TECHNICAL EVALUATION REPORT ON THE  
NEUTRON DETECTOR DECALIBRATION AT THE  
FORT ST. VRAIN NUCLEAR GENERATING STATION

(Docket No. 50-267)

March 23, 1984

Lawrence  
Livermore  
National  
Laboratory

Figure 2. Heat balance calibration

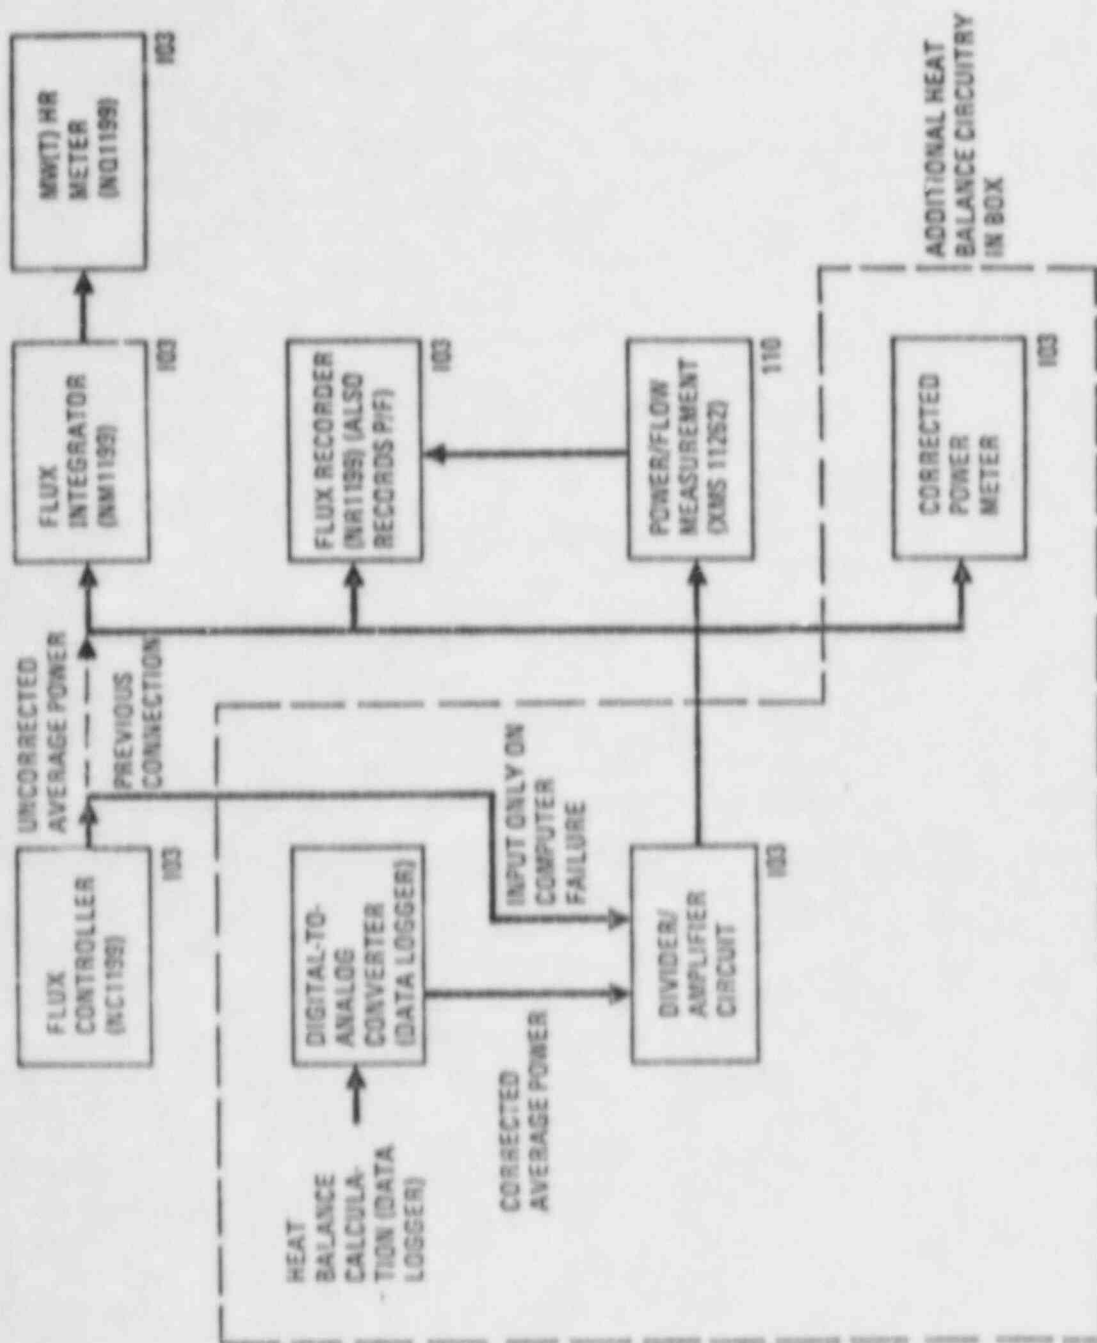
In addition to the FTSC, a circuit is added for heat balance correction as shown in Figure 2. The indicated true power as calculated from the heat balance equations in the data logger will be indicated on an added meter. The circuit will correct for non-PPS readouts, megawatt-hour meter, power and flow measurements, and the flux-recorder. It should be noted that this circuit receives an input from the data logger and is not connected with the FTSC nor part of the PPS. This circuit was not reviewed since it is independent of the change for the floating trip setpoint circuit used in the PPS.

Figure 6. Dual Linear Channel Drawer

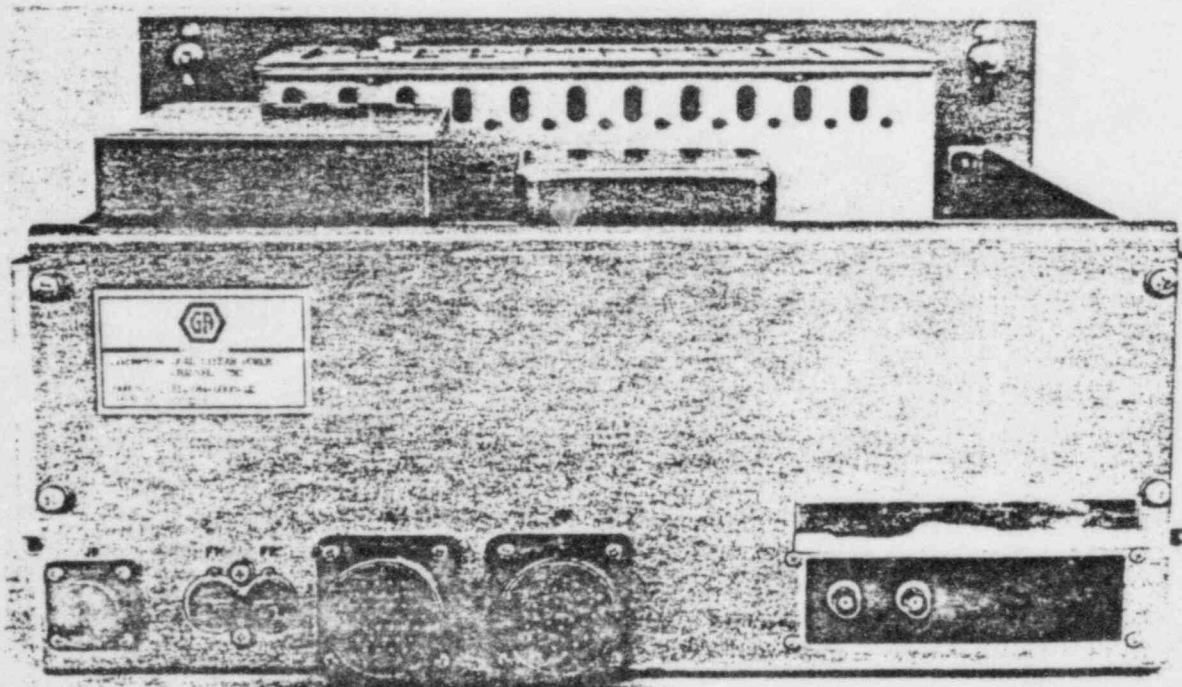
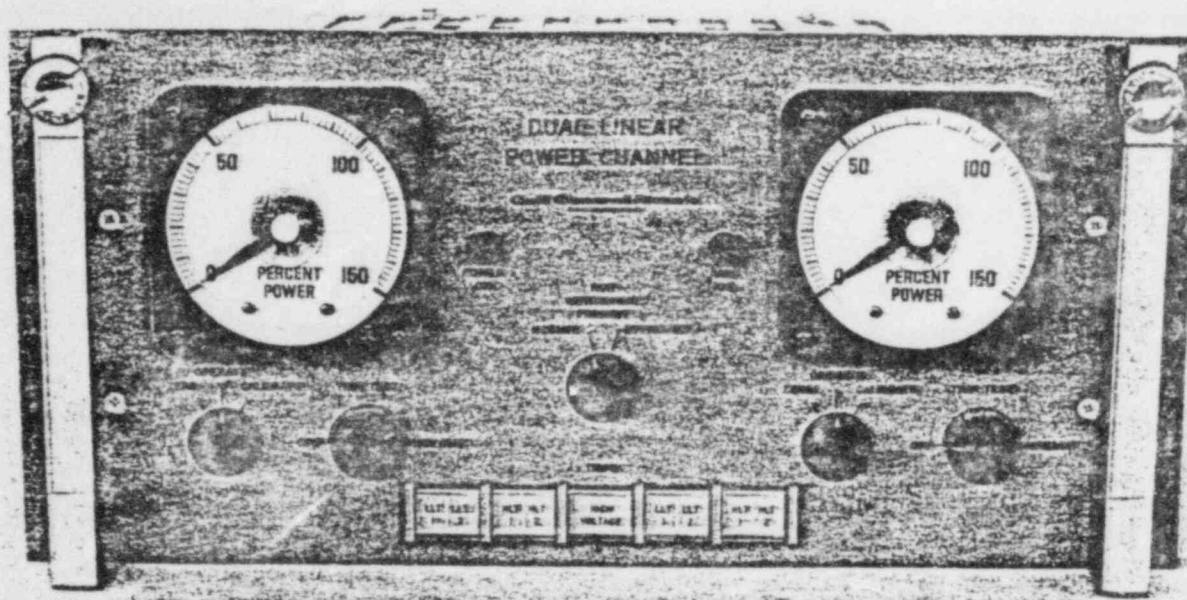
The addition of the FTSC to the PPS involves replacing the entire dual linear power range channel drawer and modules with the drawer shown in Figure 6. All the required modules (not shown) for the FTSC are located within the drawer. There are no external modifications to the drawer/modules required.

A review of drawings, schematics, and drawer specifications submitted (e.g. dual linear power channel schematic and assembly, floating trip setpoint schematic, bistable trip circuits, period rate circuits, linear amplifier schematic, and operation manual) [Ref. 3] finds that the FTSC does not alter any of the original system design criteria. This includes the criteria of redundancy, overall logic, failure modes, field wiring, arrangement, independence, testability, reliability, or physical separation of the reactor trip circuits [Ref. 4].

A review of the dual linear drawer schematic finds that the circuit boards and switches are interlocked to provide automatic channel tripping if their performing function is prohibited. The interlock path is accomplished by the +15 Vdc supply where interruption causes the bistable trips and trip relays to de-energize to their tripped condition. For loss of bus voltage or sensor, channel trip is also automatically initiated.
